# Addendum #1

Project Name:	Island Grove LED Marquees RFP
Bid Number:	FD21-01-002
Date:	January 28, 2021
Project Manager:	Abe Theiss

ISLAND GROVE REGIONAL PARK

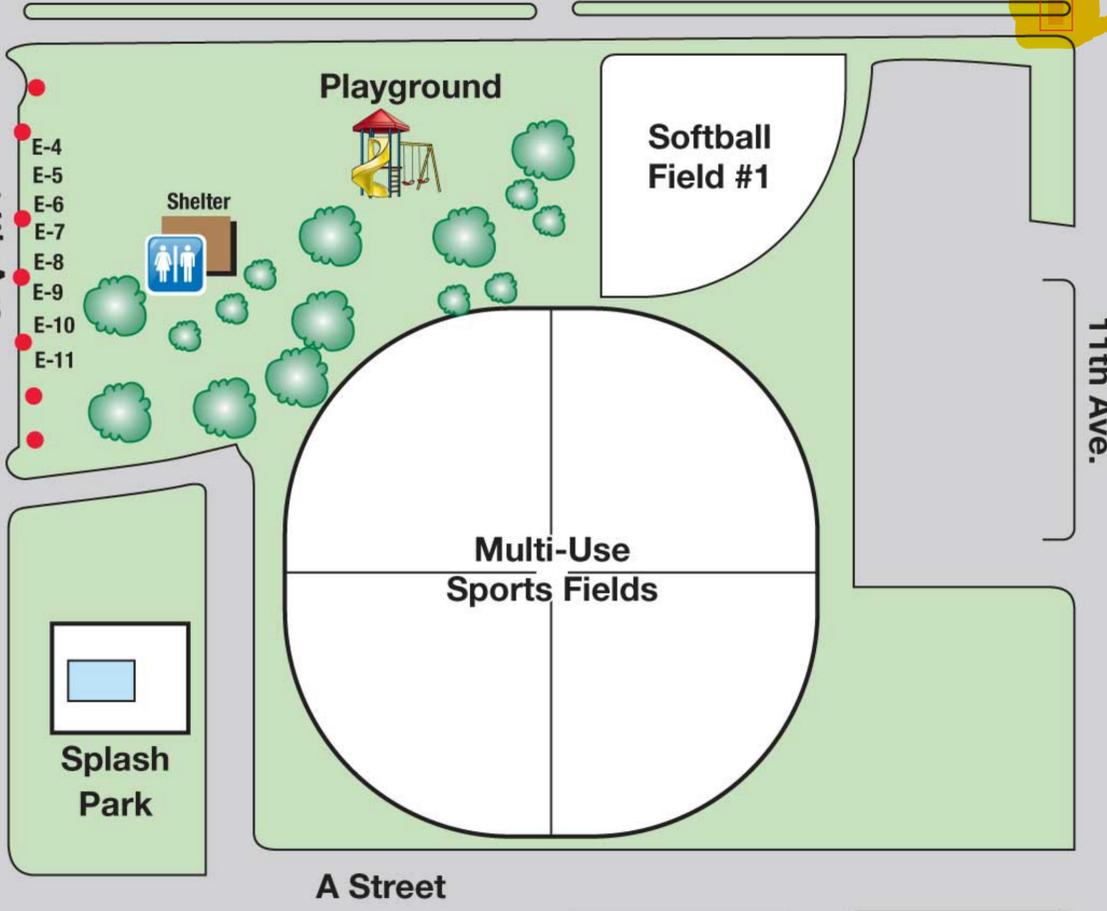
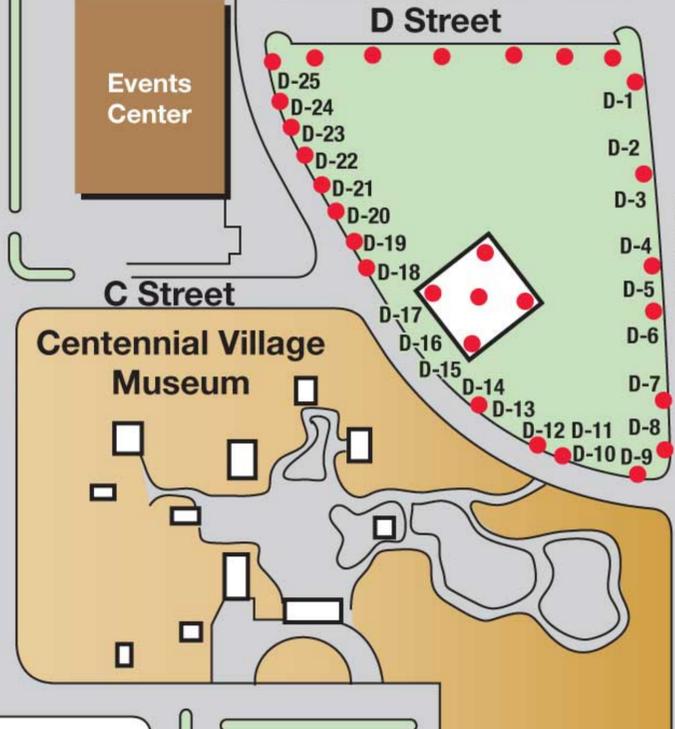
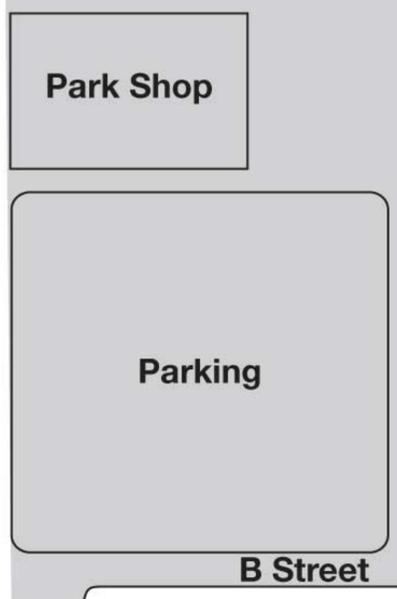
Item 35	Are there any preferred colors you want to use on these display? <a href="#">No</a>
Item 36	Do you have a map for where the displays need to be located? <a href="#">See attached map</a>
